AMENDMENT OF SOLICITATION/MODIFICATION OF CONTRACT			1. CONTRACT ID CODE	PAGE OF PAGES 1 of 10
2. AMENDMENT/MODIFICATION NO. 0002	3. EFFECTIVE DATE 13-Jan-2006	4. REQUISITION/PURCHASE REQ. NO.		5. PROJECT NO.(If applicable)

14. DESCRIPTION OF AMENDMENT/MODIFICATION (Organized by UCF section headings, including solicitation/contract subject matter where feasible.) The above numbered solicitation Lake Pontchartrain Louisiana & Vicinity Chalmette Area Plan Emergency Restoration MRGO to Caernarvon (B/L Sta. 1007+92 to B/L Sta. 1113+00) & Verret to Caernarvon (Non-Continuous) Hurricane Protection Levee St. Bernard Parish, Louisiana PROPOSAL DUE DATE AND TIME REMAIN UNCHANGED				
Except as provided herein, all terms and conditions of the document referenced in Item 9A or 10A, as heretofore changed, remains unchanged and in full force and effect.				
15A. NAME AND TITLE OF SIGNER (Type or print)			16A. NAME AND TITLE OF CONTRACTING OFFICER (Type or print)	
			TEL: _____ EMAIL: _____	
15B. CONTRACTOR/OFFEROR	15C. DATE SIGNED	16B. UNITED STATES OF AMERICA		16C. DATE SIGNED
_____ (Signature of person authorized to sign)		BY _____ (Signature of Contracting Officer)		13-Jan-2006

3. Delete dr

SHEET IDENTIFICATION NUMBER: C-12

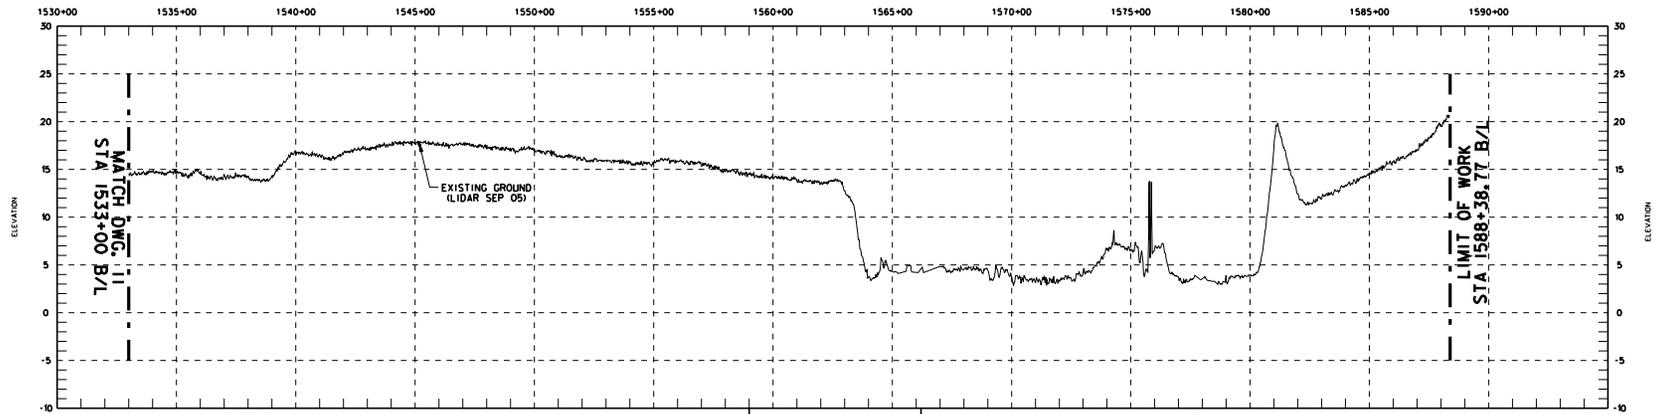
- b. For information pertaining to the replacement of the jack pedestal, see drawing C12. The removal and replacement of the screw jack will not be measured for payment. Payment will be made at the contract lump sum price for "Repair Jack Pedestal". Price and payment shall constitute full compensation for furnishing all plant, labor, material and equipment and performing all operations necessary for repairing the jack pedestal as indicated on the drawings."

1. REPAIR PROTECTED SIDE SCOUR HOLE ON EAST SIDE OF RAILROAD FLOODGATE. SCOUR HOLE SHALL BE REPAIRED BY BACKFILLING HOLE WITH CRUSHED STONE TO A LEVEL OF 4 INCHES ABOVE NATURAL GROUND.

2. FROM APPROXIMATE STA. 1561+00 TO 1572+48, ALONG ENTIRE LENGTH OF EXISTING I-WALL, FLOODSIDE EMBANKMENT SHALL BE RE-DRESSED AS FOLLOWS:
 - A. REMOVE MUCK MATERIAL CLAY.

- B. RE-SHAPE OR ADD NEW FILL TO SECTION.
 - C. FERTILIZE AND SEED EMBANKMENT.
 - D. SEE REFERENCE DRAWING H-4-26841-5 FOR DETAILS.
3. REPAIR JACK PEDESTAL AT RR GATE AS FOLLOWS:

- A. SEE REFERENCE DWG H-4-26841-19 FOR DETAILS OF SCREW JACK AND PEDESTAL.
 - B. THE NEW SCREW JACK FOR THE SWING GATE SHALL HAVE A 12-TON RATED CAPACITY WITH A 1-1/2 BY 8-INCH MALLEABLE BASE, 10-3/4-INCH CLOSED HEIGHT, 15-3/4-INCH EXTENDED HEIGHT, BELL BOTTOM, BALL-BEARING SCREW JACK AS MANUFACTURED BY SIMPLEX MODEL NO. 03090, OR AN APPROVED EQUAL.

- C. THE THREADS ON SCREW JACK, SHALL BE LUBRICATED WITH AN APPROVED LUBRICANT AND MAINTAINED IN SATISFACTORY CONDITION UNTIL ACCEPTANCE OF THE WORK BY THE GOVERNMENT.

- D. THE SCREW JACK SHALL BE FABRICATED, ASSEMBLED, AND INSTALLED IN ACCORDANCE WITH THE DETAILS AND THE MATERIALS MENTIONED ABOVE AND SHOWN ON THE REFERENCE DRAWING.
